Subject: Issuance of Amendment No. 138 to Facility Operating License DPR-57  
- Edwin I. Hatch Nuclear Plant, Unit 1 (TAC 64778)

EDWIN I. HATCH NUCLEAR PLANT, UNIT NO. 1

ATTACHMENT TO LICENSE AMENDMENT NO. 138

SAFETY EVALUATION BY THE OFFICE OF NUCLEAR REACTOR REGULATION

FIGURE 3.4-1 SODIUM PENTABORATE SOLUTION VOLUME  
VERSUS CONCENTRATION REQUIREMENTS

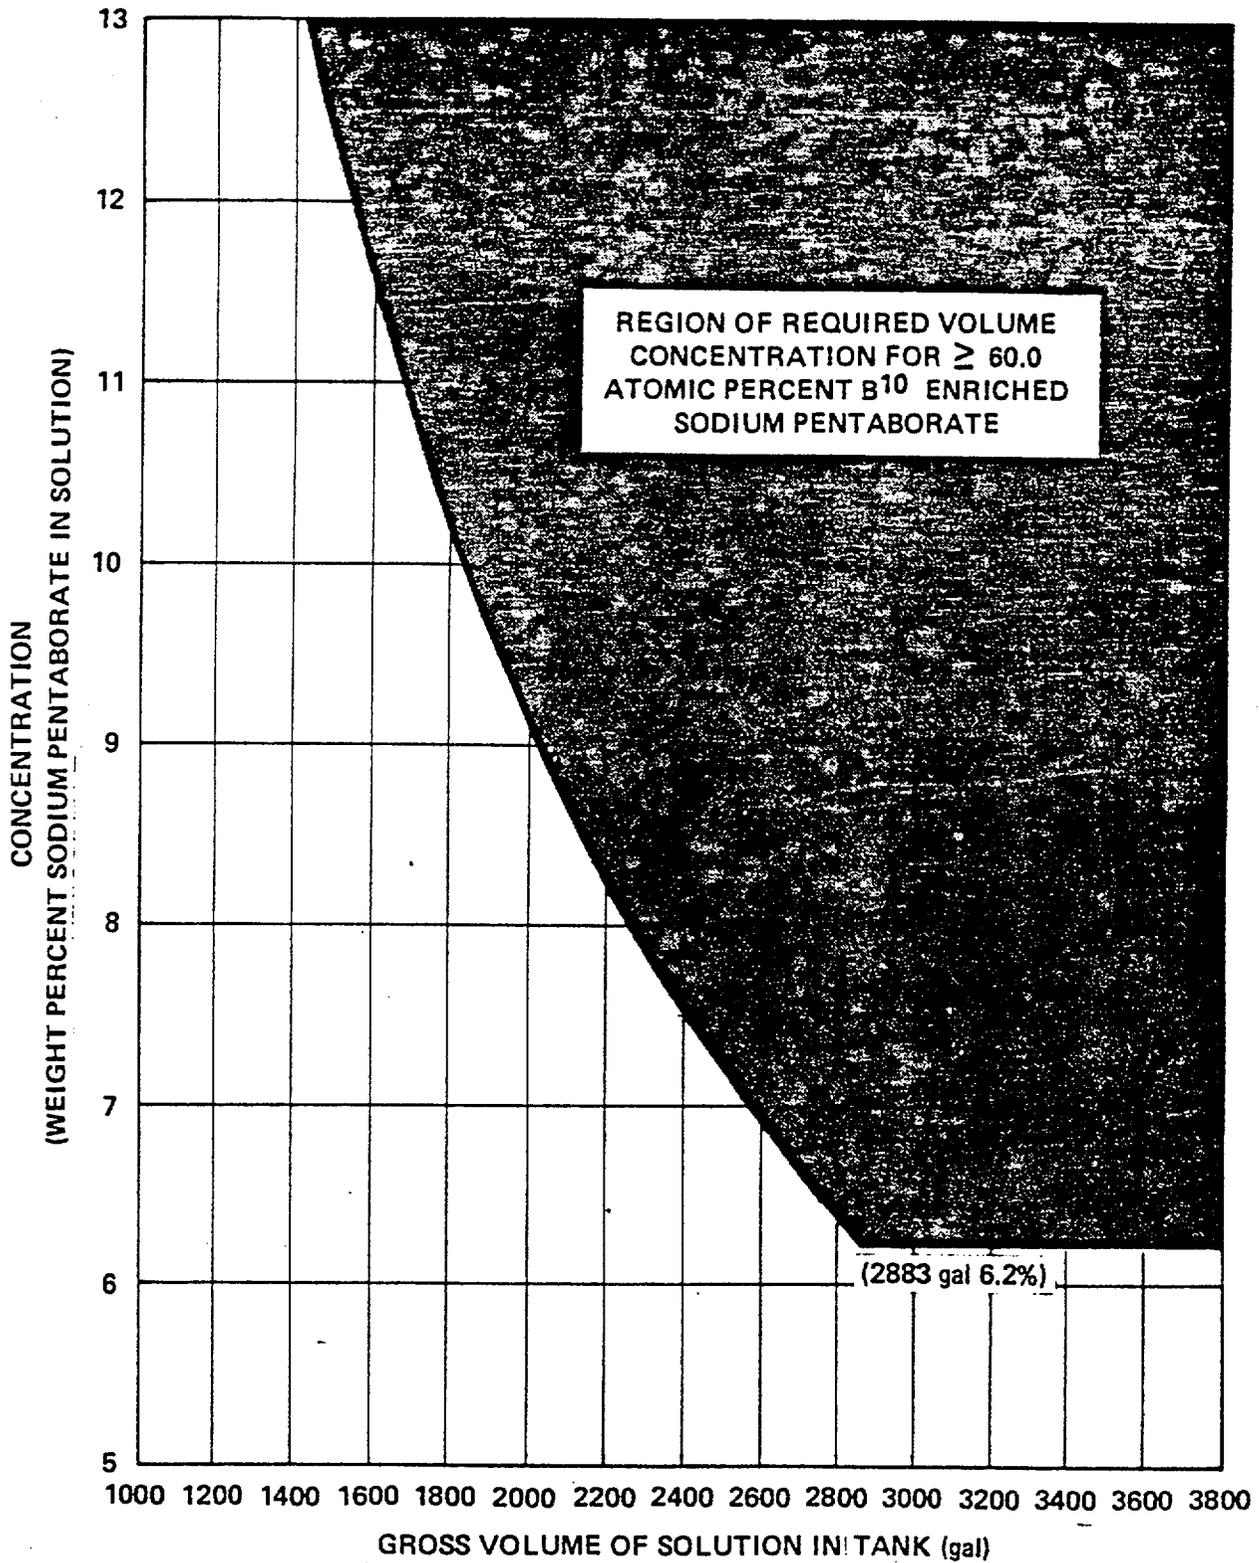
The amendment (1) reduces the limits on the Standby Liquid Control System (SLCS) sodium pentaborate solution concentration versus volume and concentration versus temperature to reflect the use of sodium pentaborate that has been enriched in Boron-10; (2) reduces the minimum acceptable SLCS pump flow rate from 43 to 41.2 gallons per minute (gpm); and (3) removes level and temperature alarm setpoint values from the concentration versus volume and the concentration versus temperature limit curves.

By letter dated February 6, 1987 (Reference 1), Georgia Power Company (the licensee) proposed changes to the Hatch Plant Unit 1 Technical Specifications (TSs) that would: (1) reduce the limits on the Standby Liquid Control System (SLCS) sodium pentaborate solution concentration versus volume and concentration versus temperature to reflect the use of sodium pentaborate that has been enriched in Boron-10; (2) reduce the minimum acceptable SLCS pump flow rate from 43 to 41.2 gallons per minute (gpm) in order to conform with the 41.2 gpm minimum acceptable flow rate for Hatch Unit 2; and (3) remove level and temperature alarm setpoint values from the concentration versus volume and the concentration versus temperature limit curves. The proposed changes would result from the use of boron enriched in the isotope B-10 in the SLCS in order to meet the requirements of the Anticipated Transient Without Scram (ATWS) rule, 10 CFR 50.62. The current Technical Specifications are based on the use of sodium pentaborate unenriched in the B-10 isotope. The proposed changes are to TS Figure 3.4-1 and 3.4-2, to TS 4.4.A.2.b, and to Basis 3.4, all associated with the SLCS.

The changed values lead to proposed changes in the TS. This includes a change from 43 to 41.2 gpm pump rate in TS 4.4.A.2.b, and changes to Figures 3.4-1 and 3.4-2 giving required sodium pentaborate (1) concentration as a function of gross volume of solvent in the tank and (2) temperature as a function of concentration. (Unneeded alarm setpoints, used for information only, would be removed from the figures.) These changes are the result of straightforward calculations and are reasonable and acceptable. The related Basis 3.4 has also been changed to reflect the revised approach and requirements. This, too, is acceptable.

The volume limits in Figure 3.4-1 are calculated such that for a given concentration of sodium pentaborate, the tank contains a volume of solution adequate to bring the reactor to a cold shutdown, with margin. These volume limits are based on gross volume and account for the unusable volume of solution in the tank and suction lines.
